ARCHITECT'S ADDENDUM

Addendum Number: 002

RE: EASD #131 East Aurora High School
2027 Mechanical Improvements

Subject: Addendum No. 002 to the Construction Documents for the EASD #131 East Aurora High School 2027 Mechanical Improvements Project.

B-A2.21

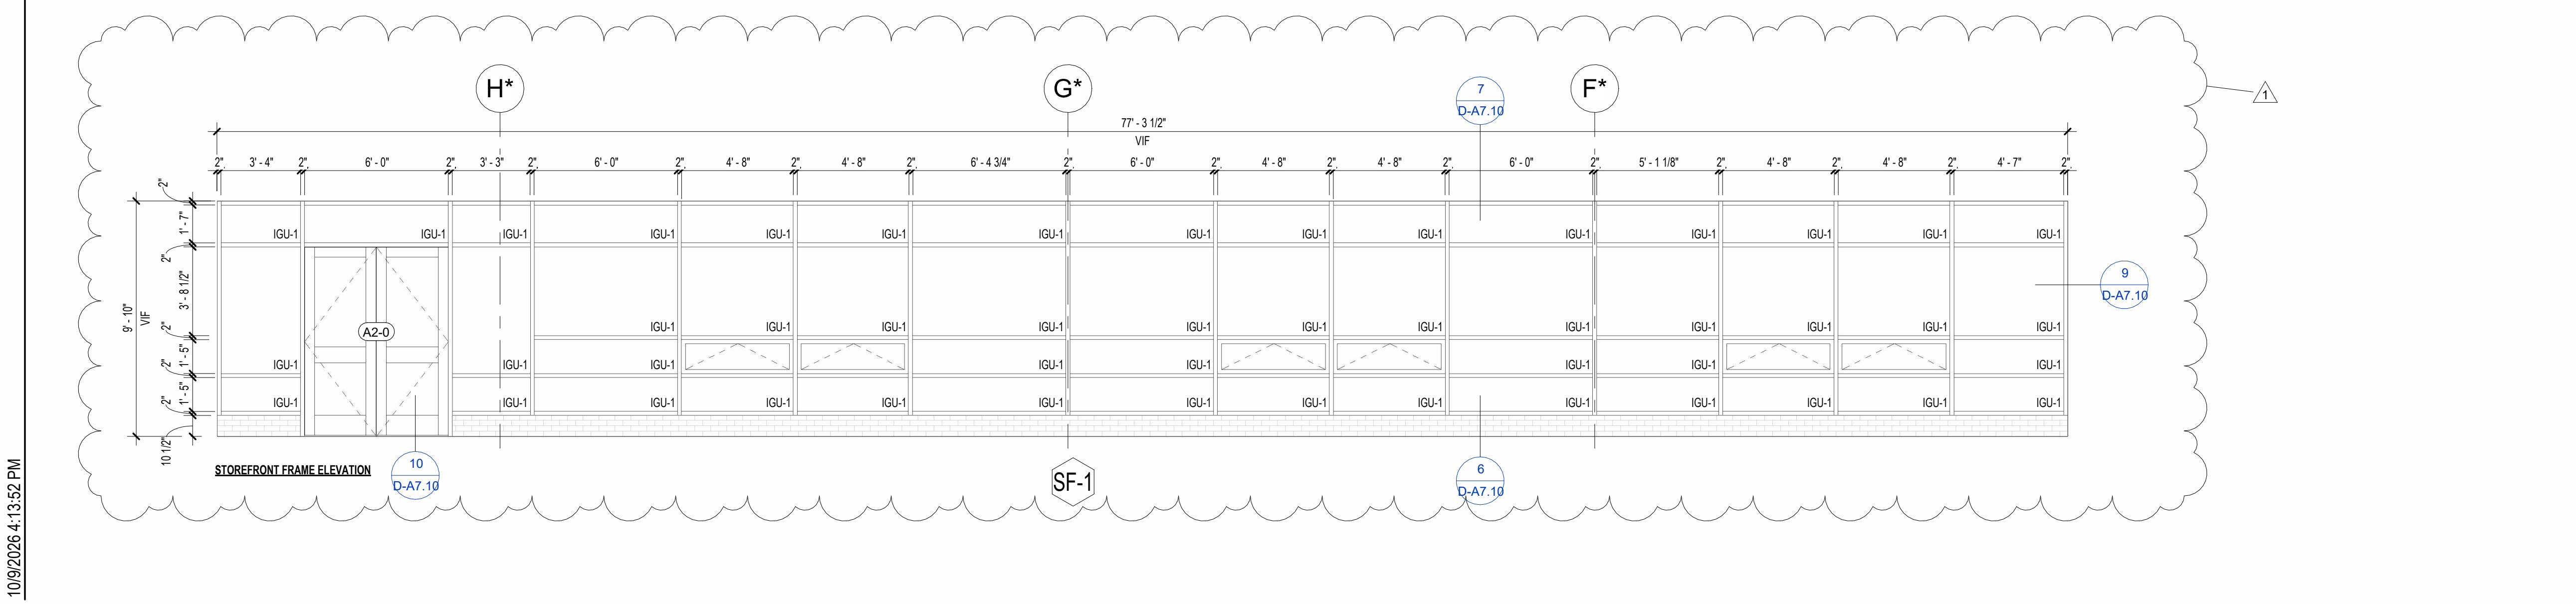
1. B-A2.21 – AREA B – FIRST FLOOR PLAN

- **ADDED** section detail tags for Storefront Frame Elevation SF-1. Detail references for head, jamb, and sills can be found on D-A7.10.

B-A2.51

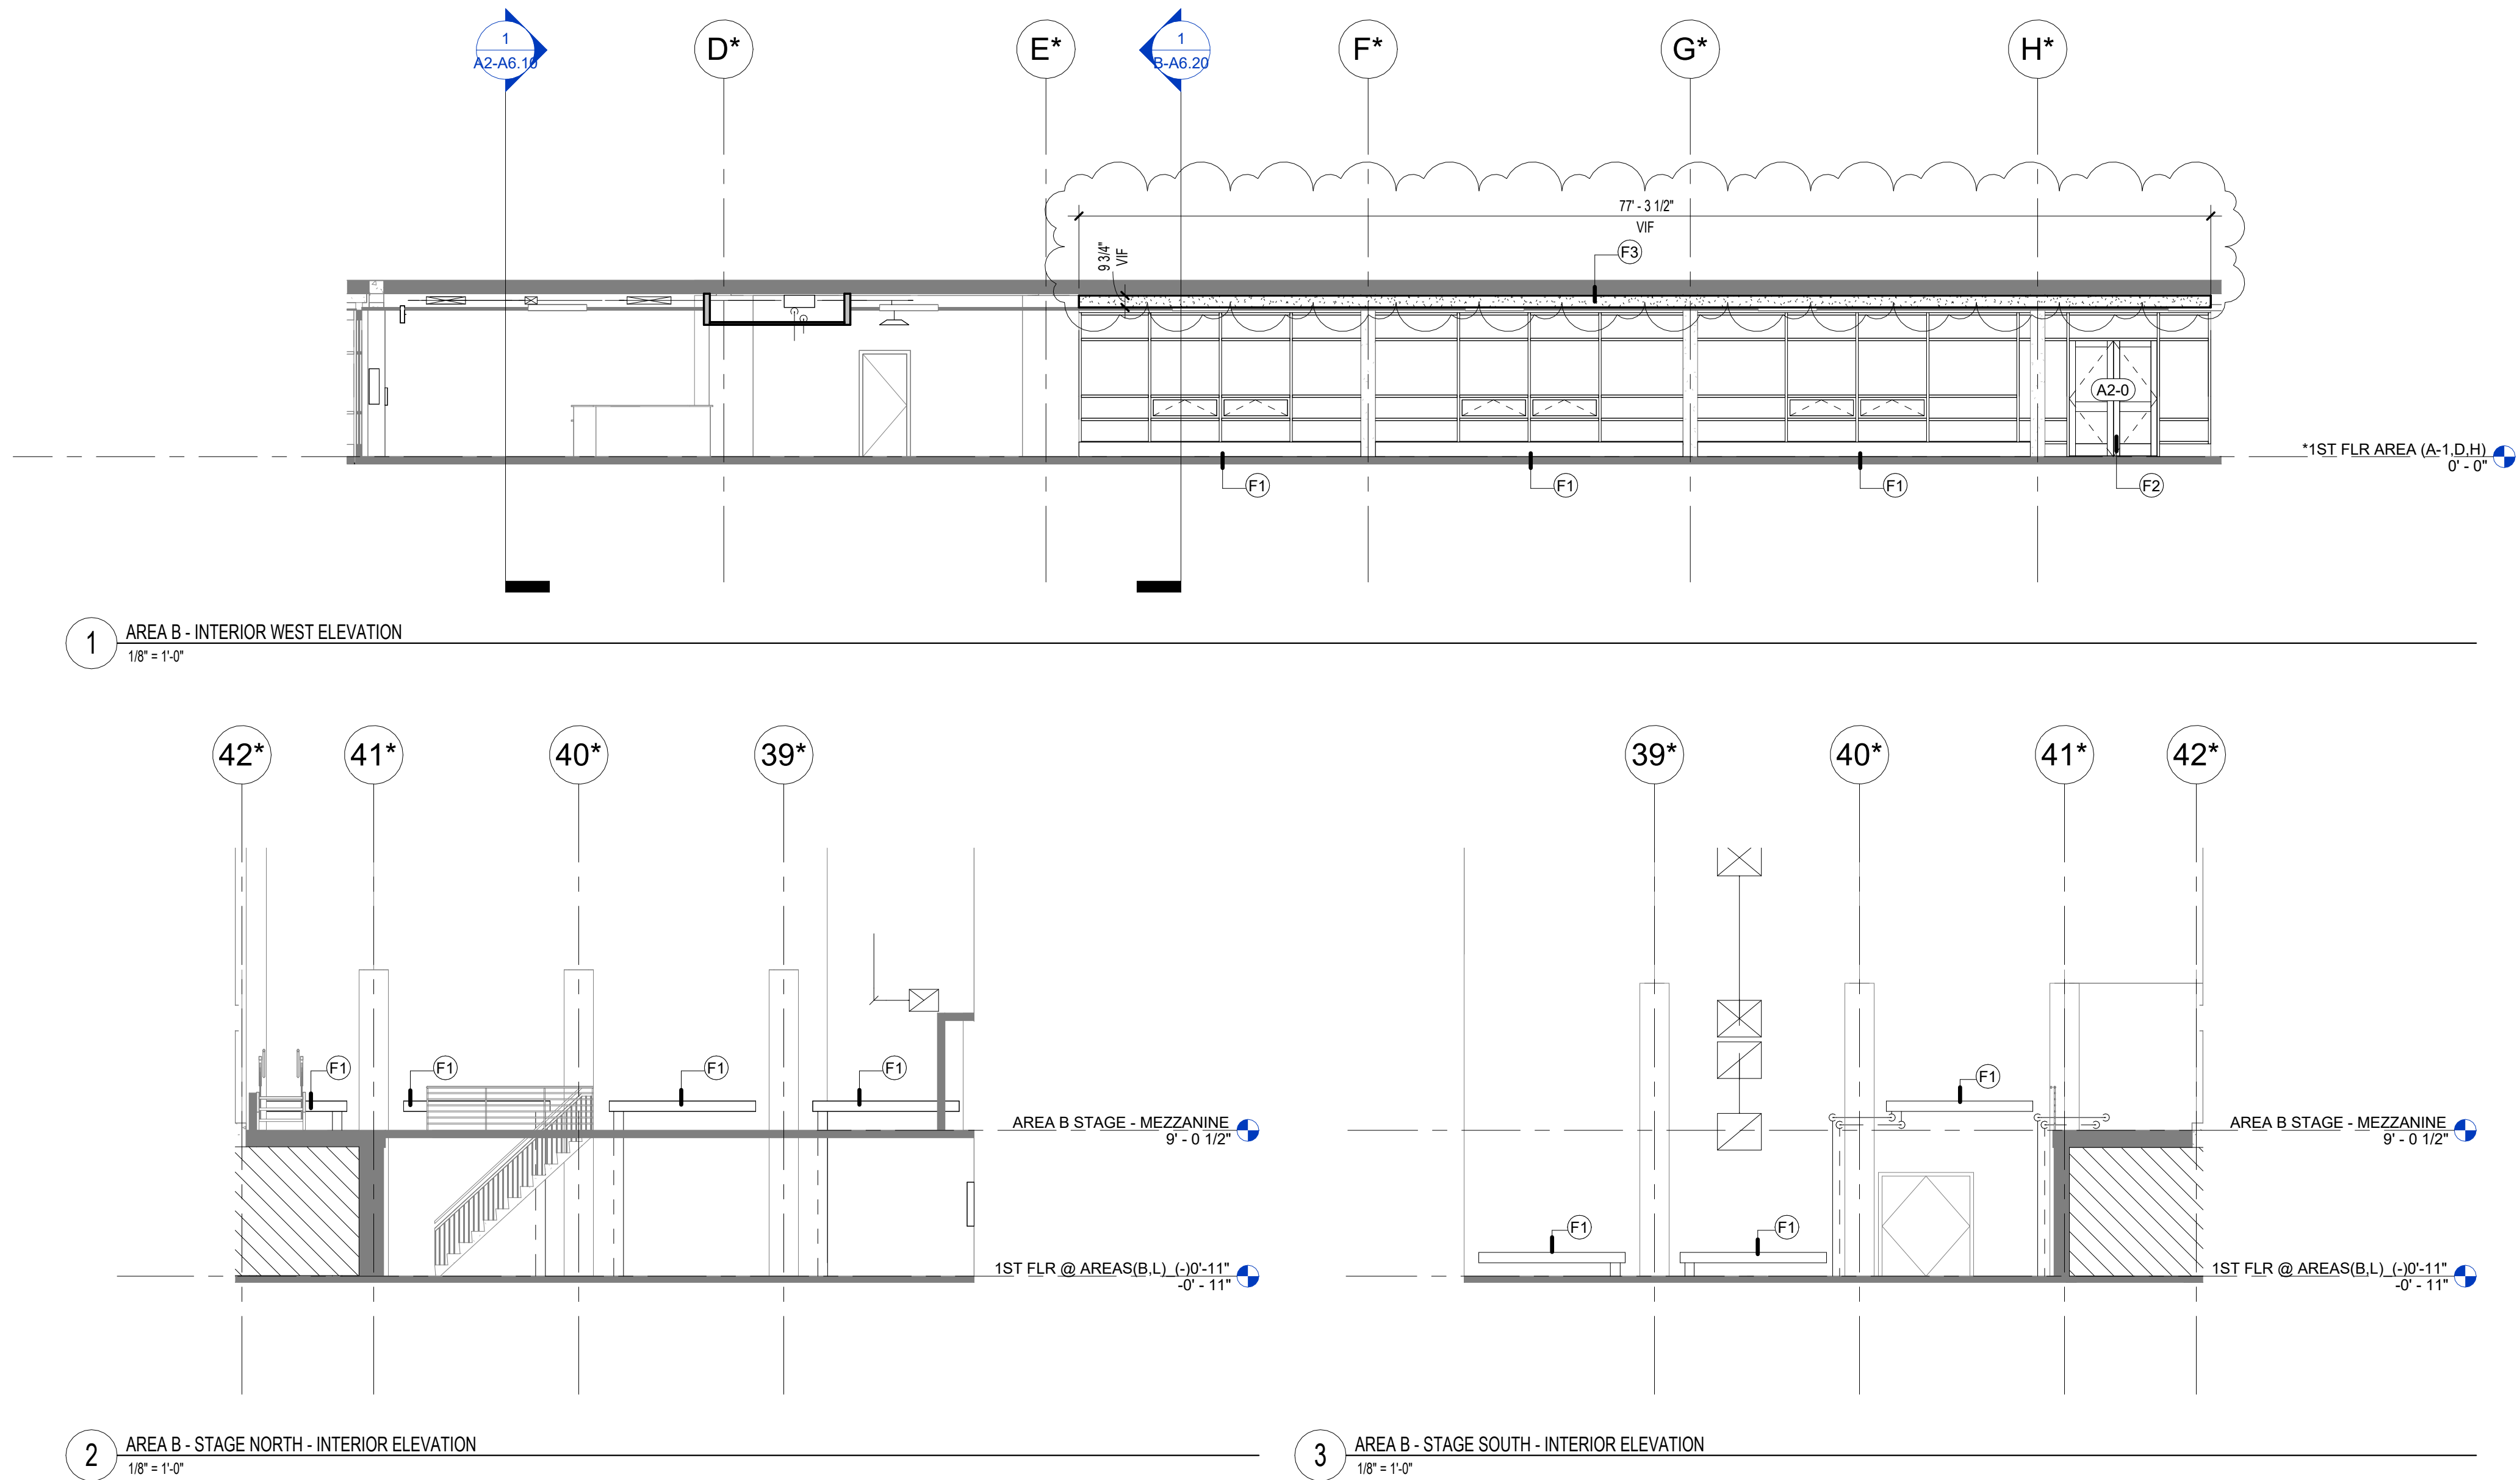
2. B-A2.51 – AREA B – INTERIOR ELEVATIONS

- New Work Keynote Clarifications are as follows, refer to revised drawings for more detail:
F3. New spray foam insulation noted with “F3” keynote.

DRAWING TITLE:
AREA B - FIRST
FLOOR -
REFLECTED
CEILING PLAN

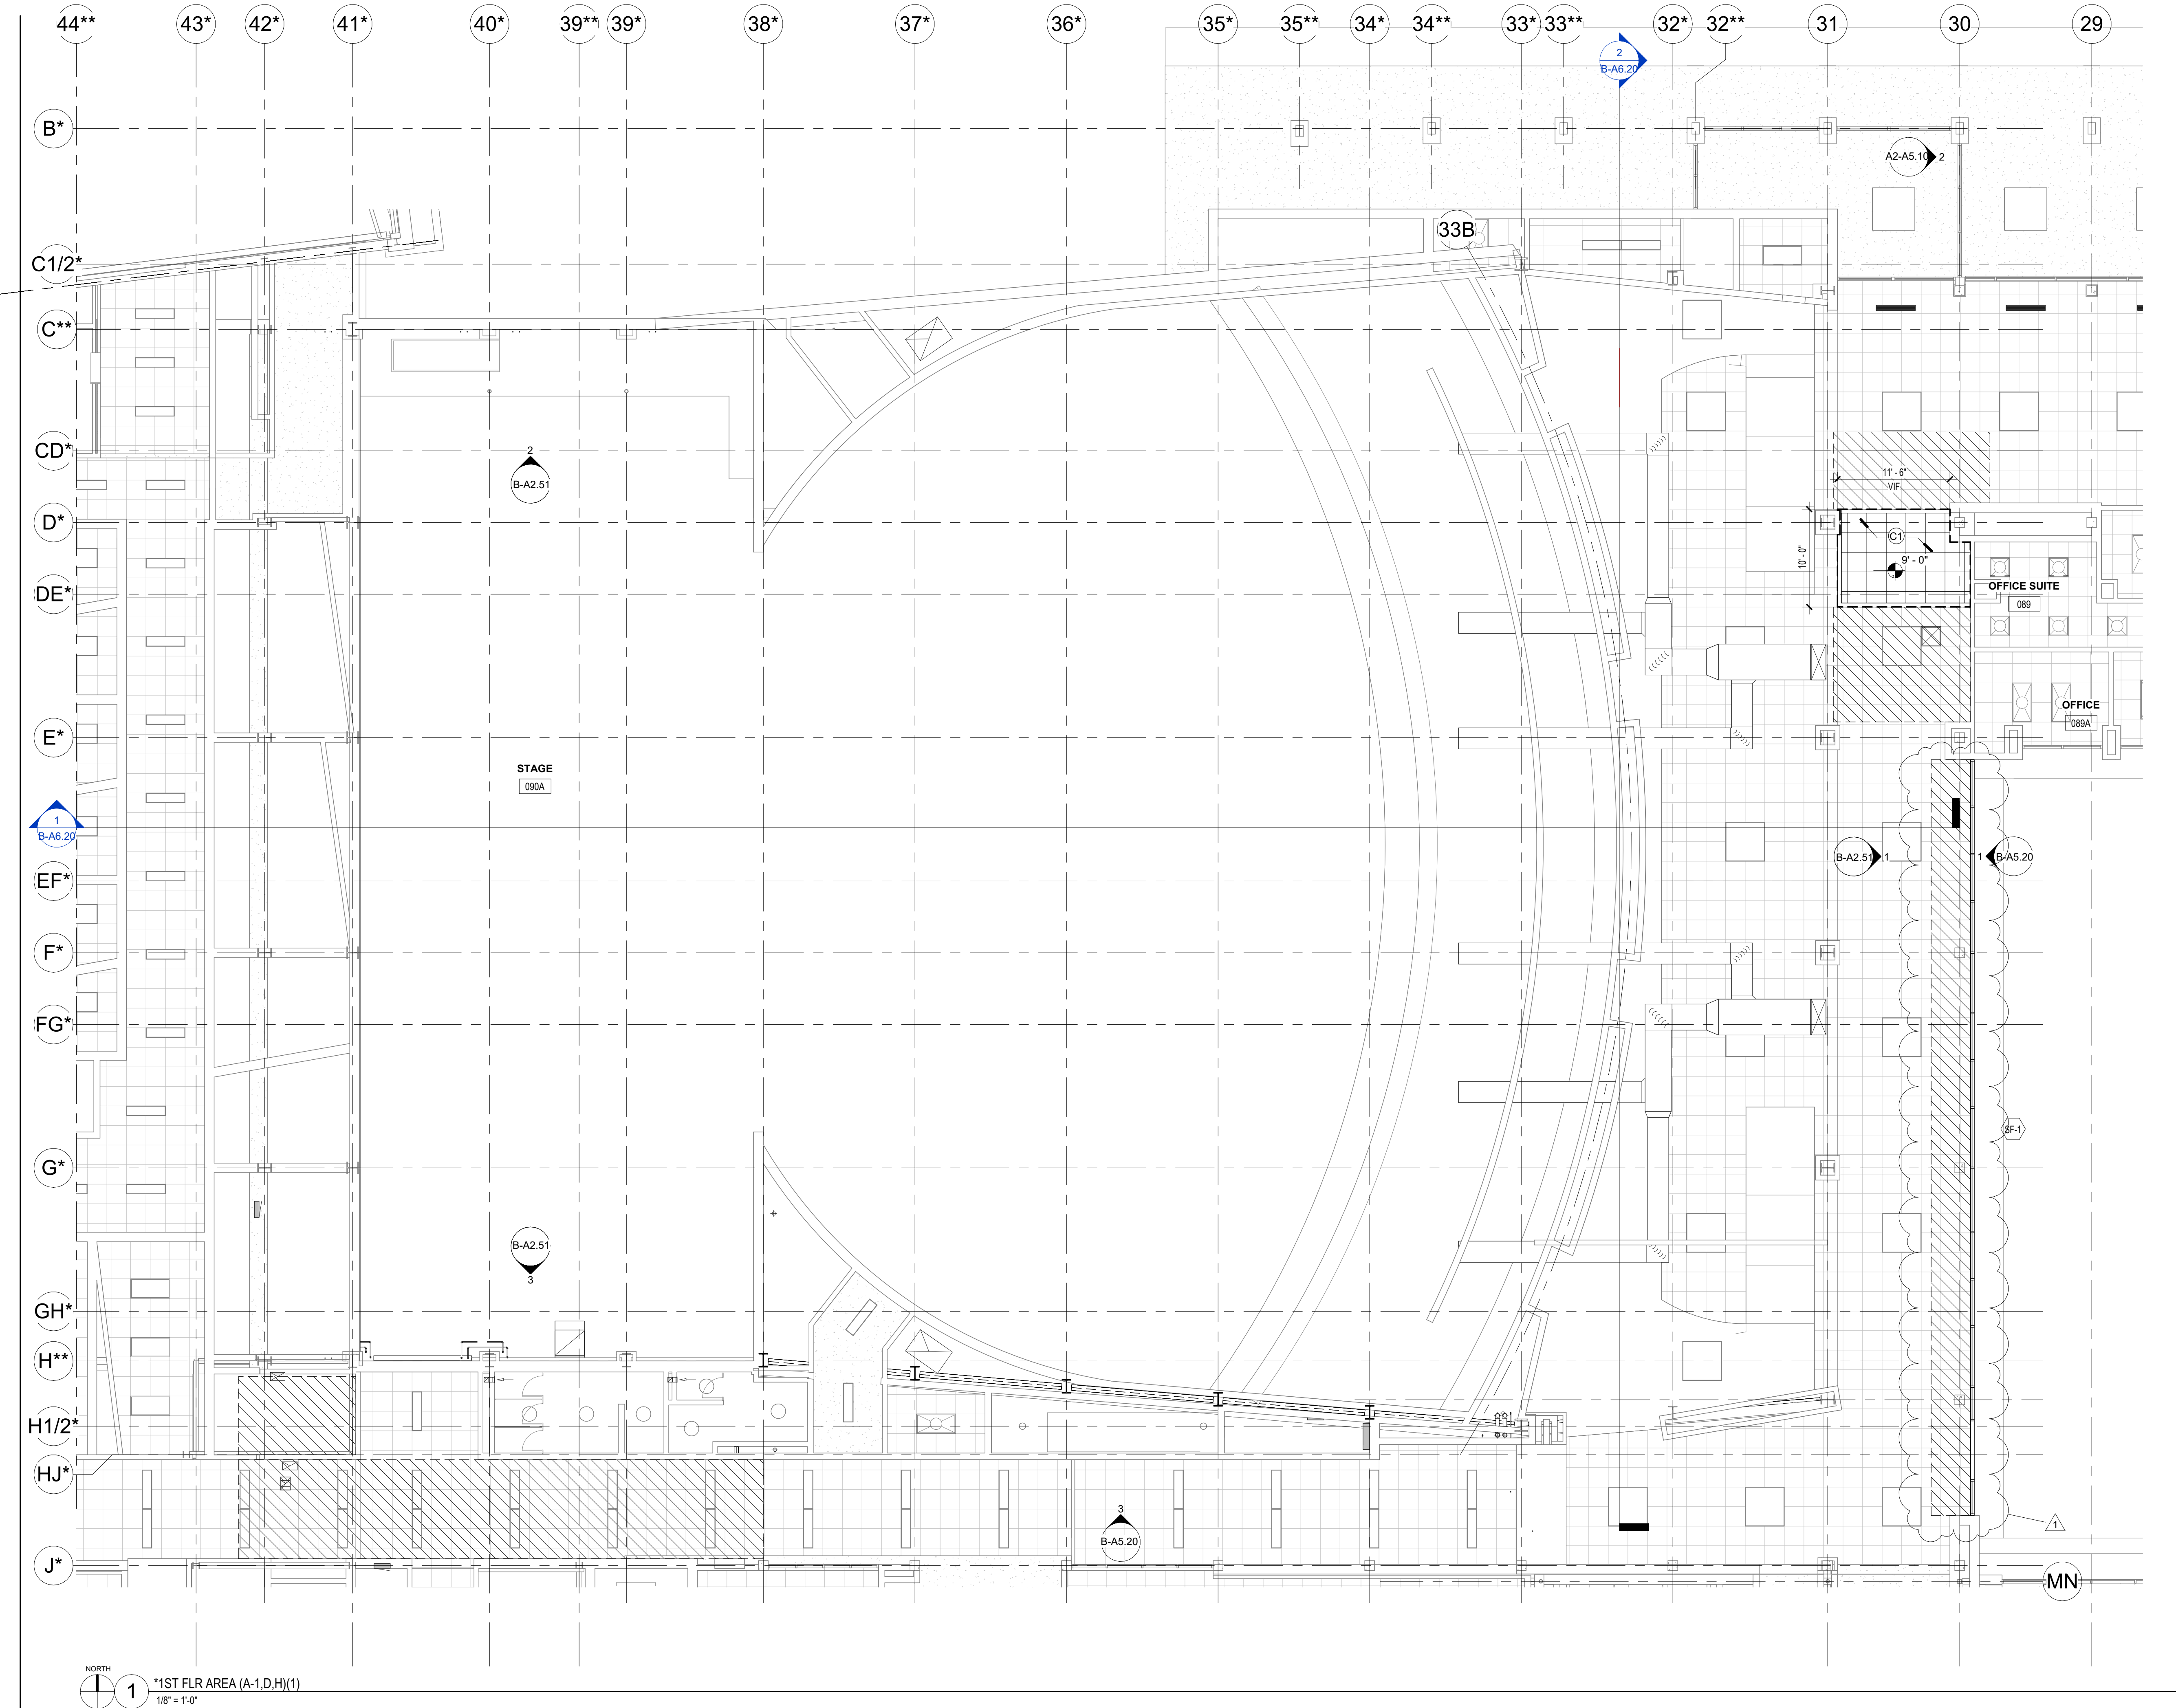
3. B-A3.21 – AREA B – FIRST FLOOR – REFLECTED CEILING PLAN

- **ADDED** ceiling removal and reinstallation work hatched region near new Storefront SF-1.

5 AREA C - CORRIDOR CROSS SECTION
1/8" = 1'-0"

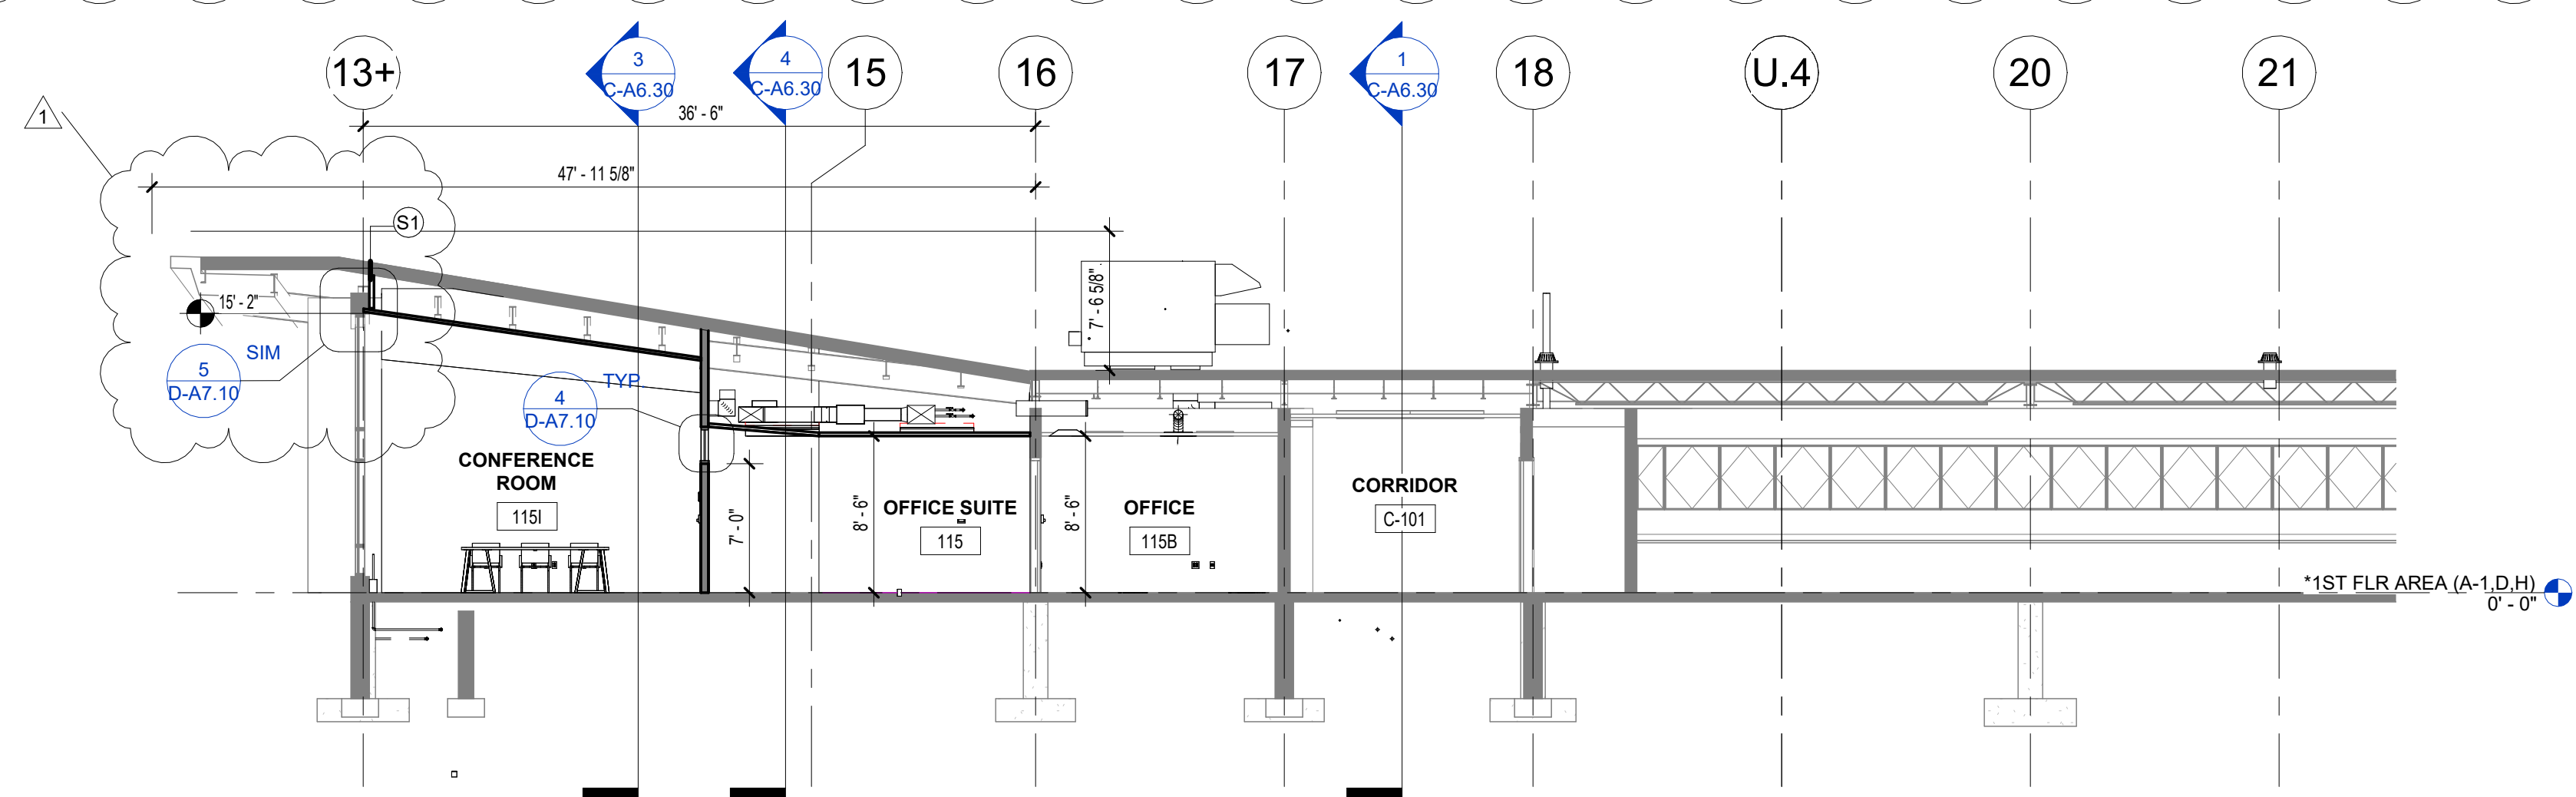
7. C-A6.30 – AREA C – BUILDING SECTIONS

- **ADDED** Area C- Corridor Cross Section.
- **ADDED** Section New Work Keynotes – Area C.
- New Work Keynote Clarifications are as follows, refer to revised drawings for more detail:
S1. New spray foam insulation noted with “S1” keynote.
